**Written submission from
Frank R. Greening**

**Ontario Power Generation Inc.,
Pickering Nuclear Generating Station**

Request for a ten-year renewal of its Nuclear Power Reactor Operating Licence for the Pickering Nuclear Generating Station

Re: Supplemental material for my submission to the CNSC Public Hearing to consider Ontario Power Generation's (OPG's) application to renew its Nuclear Power Operating Licence for the Pickering Nuclear Generating Stations, A and B, for a period of 10 years, Hearing Number Ref. 2018-H-03

Deuterium Pickup by Pickering Pressure Tubes as a Function of Hot Hours of Exposure

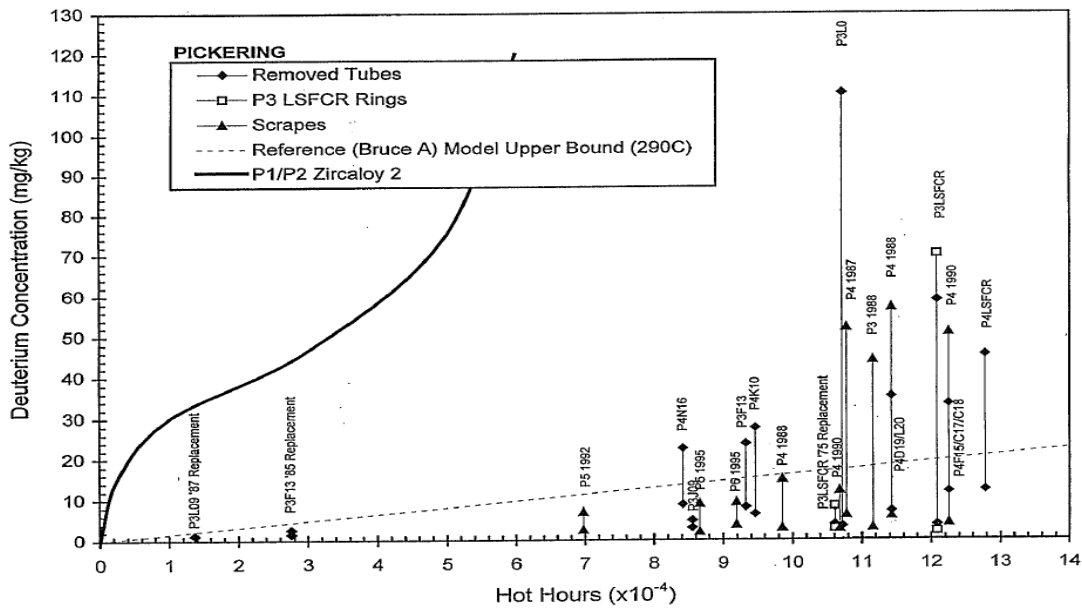
Although not explicitly stated, this quote amounts to an admission that deuterium pickup by CANDU pressure tubes is subject to so many causative factors *that it is essentially impossible to reliably predict future trends in the deuterium content of any particular pressure tube.* This is especially evident when deuterium pickup data are plotted as a function of the in-reactor exposure of the pressure tube, as shown below, where the large variability in deuterium pickup is clearly evident.

CNL Deuterium Uptake vs. Hot Hours of In-Reactor Exposure

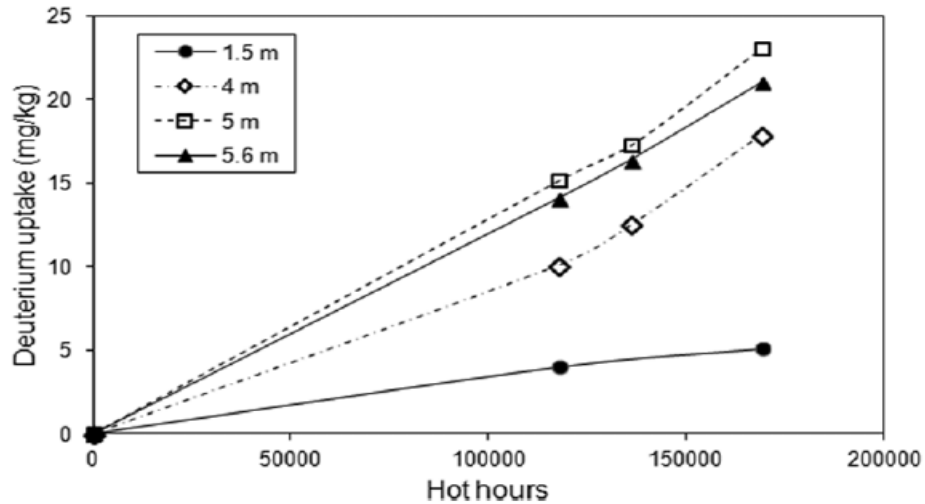
A comparison of CNL’s plot with OPG’s data for Pickering reveals that many pressure tubes show deuterium pickups that are well above the values depicted in the CNL plot. Thus, for example, the CNL “representative behavior” for deuterium pickup near the outlet of a pressure tube is about 15 mg/kg after an in-reactor exposure of 120,000 hot hours, which is equal to $1.25 \text{ mg/kg}/10^4 \text{ Hot Hours}$. By comparison, OPG’s data indicate that many Pickering pressure tubes show deuterium pickups in excess of 40 mg/kg after in-reactor exposures of 120,000 hot hours, which is equal to $3.3 \text{ mg/kg}/10^4 \text{ Hot Hours}$.

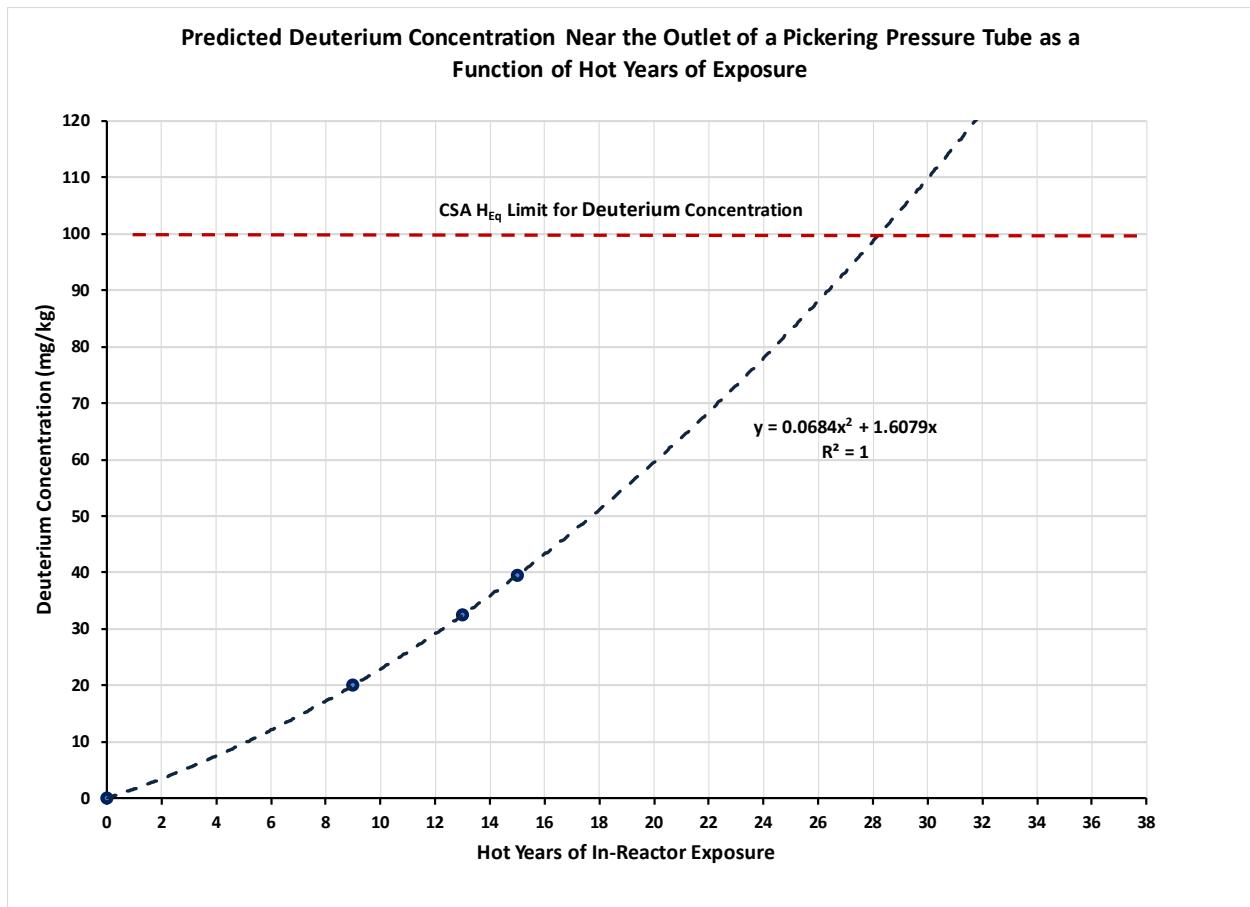
A best fit of such data, extrapolated to 32 hot years, is shown below. The plotted data clearly demonstrate that Pickering B is predicted to reach the CSA-imposed limit of 100 mg/kg H_{Eq} *well before the required 31 hot years*. It would be very helpful and informative for OPG to publish *measured* deuterium pickup data for Pickering B to confirm or deny this conclusion.
